REMARKS

Enclosed are two sheets of marked-up, amended drawings, Pages 1 and 18, each of which has been labeled "Annotated Sheet". Proposed changes to Sheets 1 and 18 are shown in red ink.

-- MICROMACHINED INTEGRATED FLUID DELIVERY SYSTEM ~~WITH DYNAMIC~~
~~METAL SEAT VALVE AND OTHER COMPONENTS~~ FOR SEMICONDUCTOR PROCESSING
EQUIPMENT --

Fig. 1

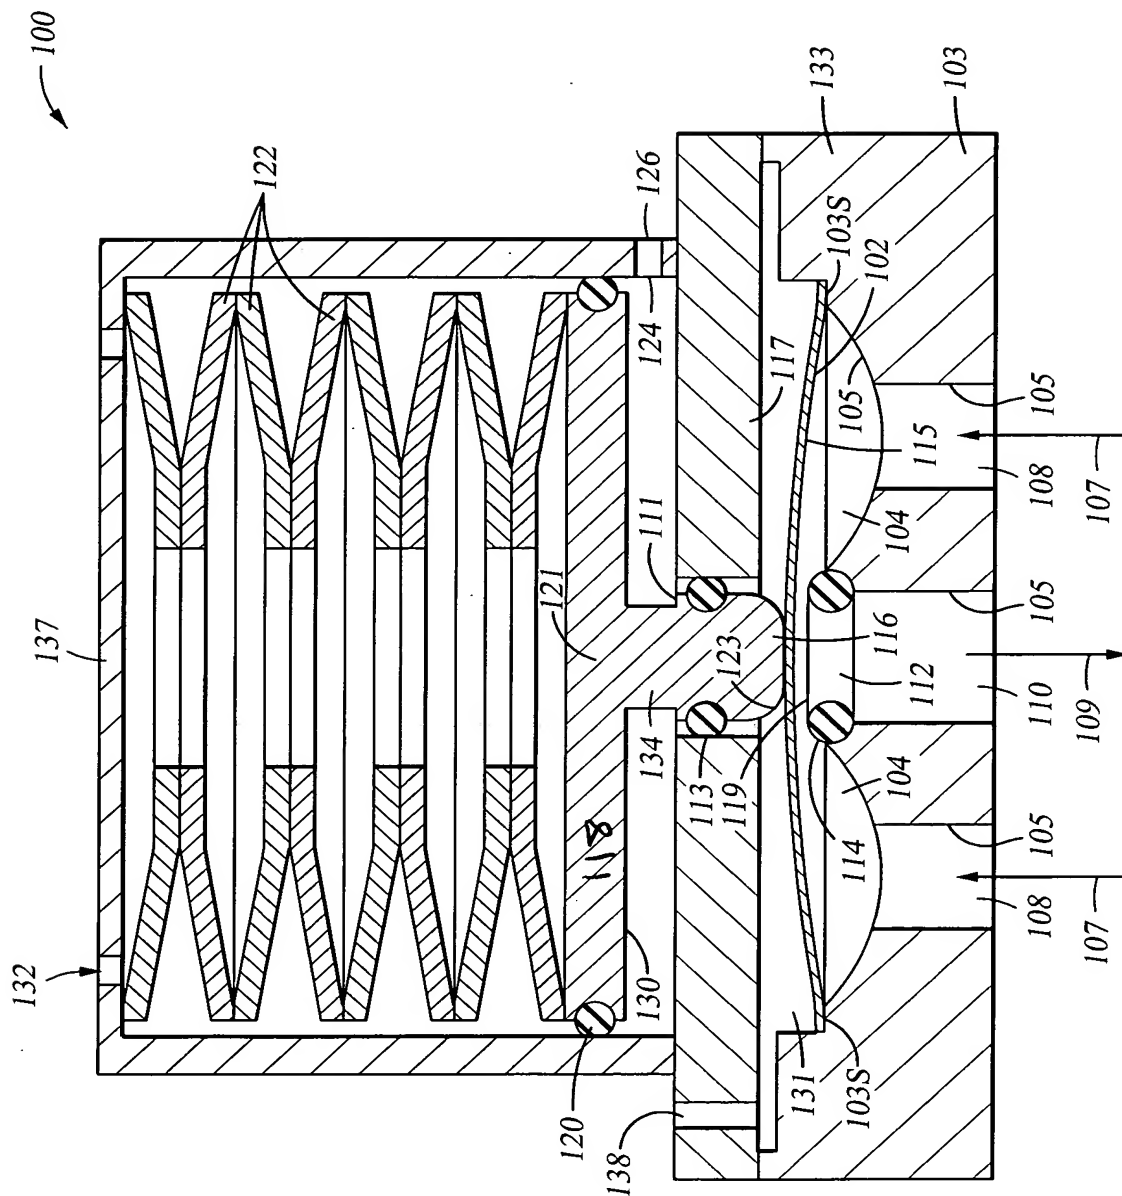
In particular, Figure 1 on Sheet 1 has been amended to include reference numeral 118, which refers to the upper horizontal member of sliding cylinder 121. This corresponds with upper horizontal member 318 of sliding cylinder 321 in Figure 3, for comparison purposes. Paragraph [0069] of applicants' specification has been amended, as set forth above, to include reference to upper horizontal member 118 and vertical member 134 (which was numbered, but was not previously referenced in the specification). The amendments to Figure 1 and to Paragraph [0069] are supported at page 7, lines 4 - 6, of Paragraph [0023] of applicants' originally filed specification.

[0069] The sliding cylinder 121 has an upper horizontal member 118 connected to a smaller, lower horizontal member 116 by a vertical member 134. When the valve 100 is in the closed position, the fluid flow is interrupted by a section of the diaphragm 102 being pressed tightly against an upper surface 119 of the metal valve seat 114 by lower horizontal member 116 of sliding cylinder 121. The lower surface 123 of lower horizontal member 116 is convex-shaped, so that it can act as a backing disk behind diaphragm 102. Lower horizontal member 116 is considered to be part of drive section 106, since lower horizontal member 116 is not wetted by fluids passing through valve 100. The diaphragm 102 may be free-moving, or may be bonded to the convex surface 123 of lower horizontal member 116, for example, by e-beam welding, or direct bonding, or other bonding techniques known in the art. The convex surface 123 of lower horizontal member 116 which contacts diaphragm 102 is typically made of a material which has a hardness less than that of the diaphragm material. If the diaphragm 102 is made of a nickel-cobalt alloy (for example, and not by way of limitation, ELGILOY®, SPRON™ 510, SPRON™ 100, HASTELLOY®, or

Fig. 10

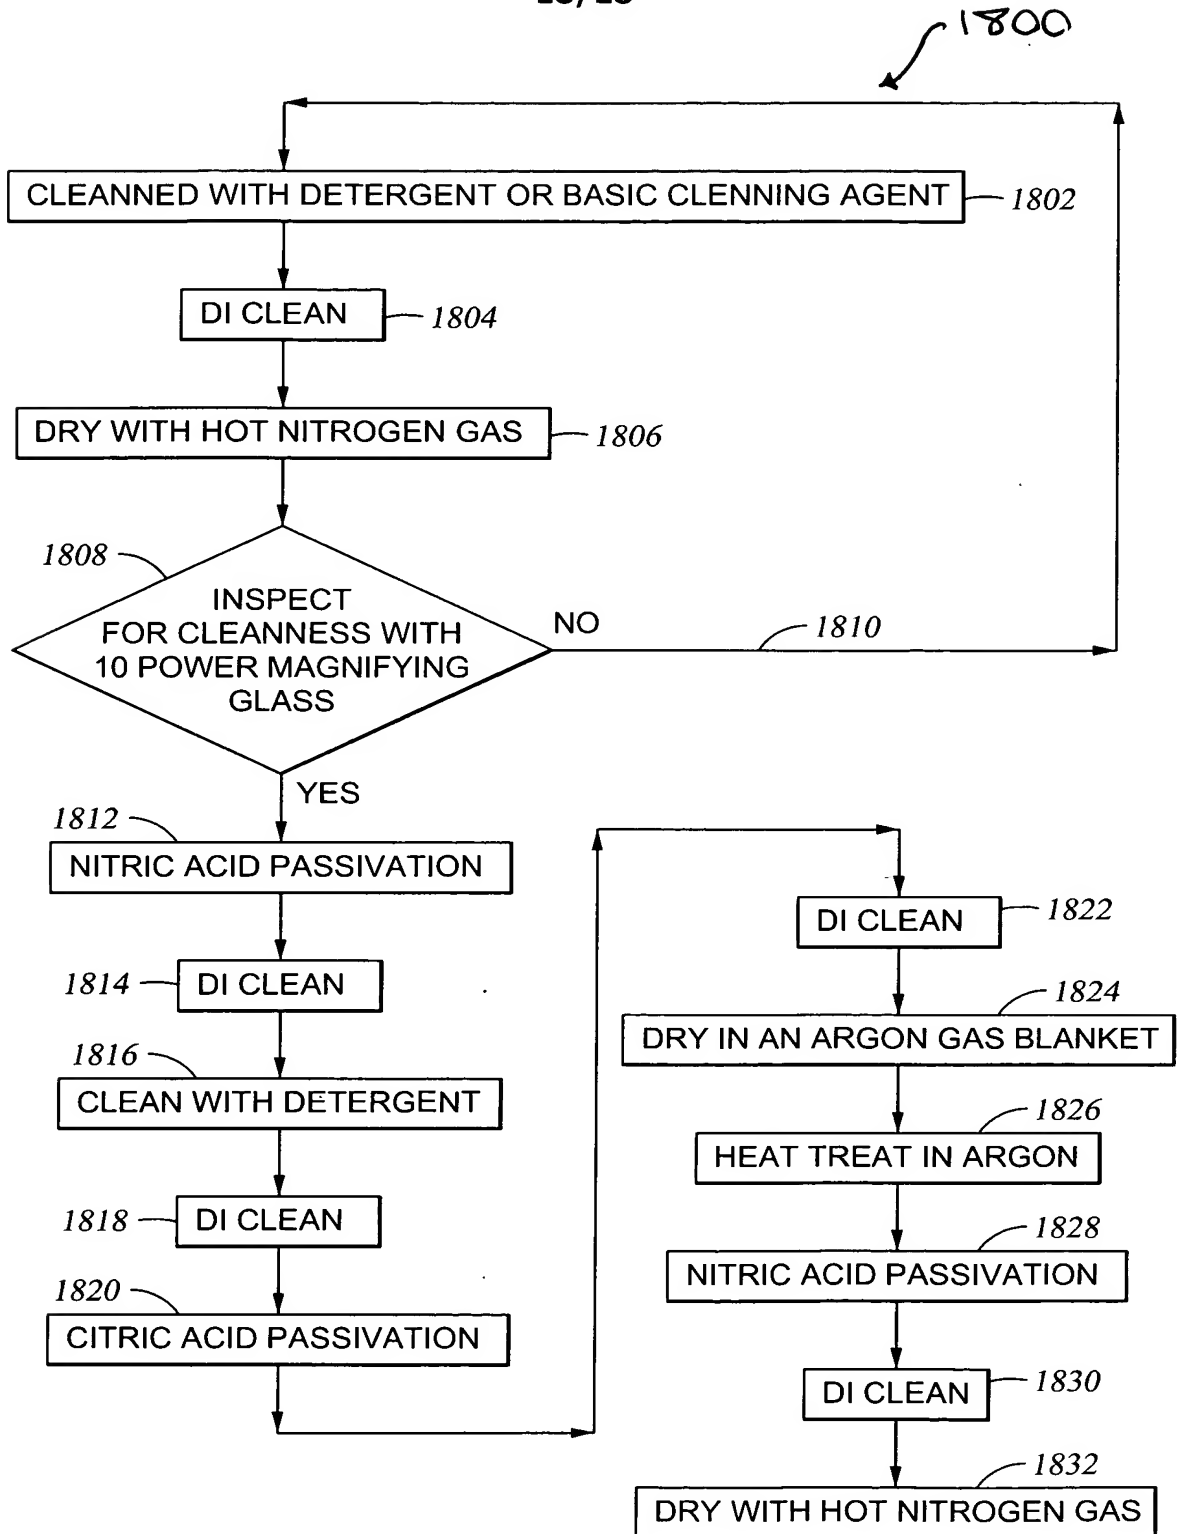
Figure 10 on Sheet 18 has been amended to include reference numeral 1800, which refers to the process diagram for the stainless steel treatment method. The amendment to Figure 10 is supported at page 31, lines 11 - 13, of Paragraph [0106] of applicants' originally filed specification.
